Testimony of Kristin Taddei, Planning Advocate, Casey Trees June 5, 2017

Before the Zoning Commission on The River Front Development ZC Case No. 17-05: 2100 2nd Street, SW, LLC

Figure 1. Existing tree canopy. The majority of these trees are in poor condition.

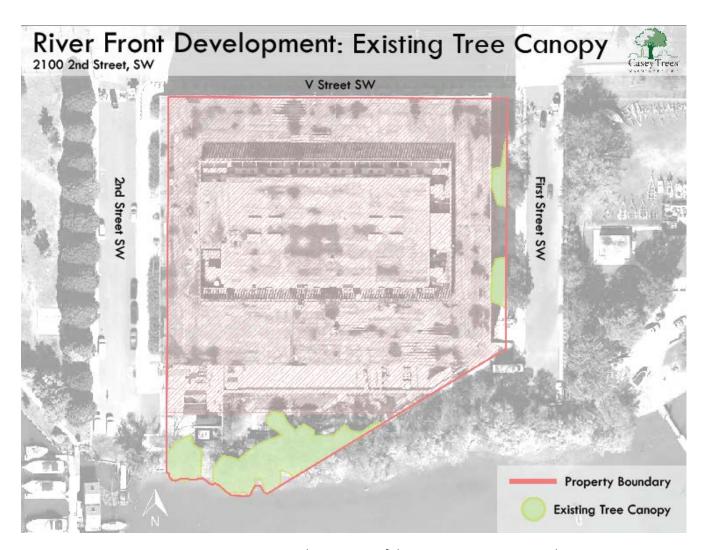
Though there are trees on this property today, many of them are in poor condition, especially those growing along the riverbank and eastern side of the proposed building (Figure 1). We appreciate that 2100 2nd Street, SW LLC will replace these neglected trees with carefully selected, urban-hearty trees that will be well cared for. These trees will ultimately improve the river ecosystem and provide shade to passersby. To continue working toward the city's <u>Sustainable DC</u> goal of achieving a 40% tree canopy by 2032, and the <u>ClimateReady DC</u> actions to reduce flooding and the urban heat island effect, we recommend the following:

Figure 2. In addition to the developer's proposed plantings along the riverfront, we recommend planting small trees in the 4' wide planting strips along the eastern edge of the building.

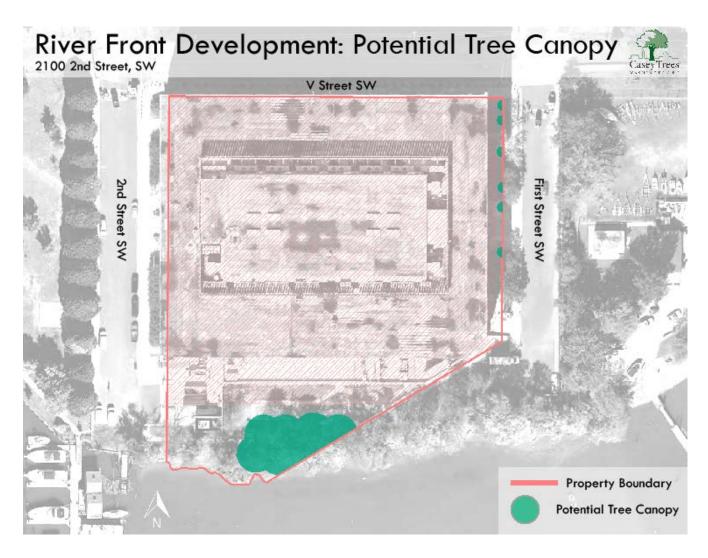
1. Plant small trees on the eastern edge of the property. There is an opportunity to plant small trees in the 4' wide planting strips proposed along the eastern edge of the building. We suggest ensuring there is at least a 3' soil depth in these planting strips, and spacing 6 small trees at least 10 feet apart (Figure 2).
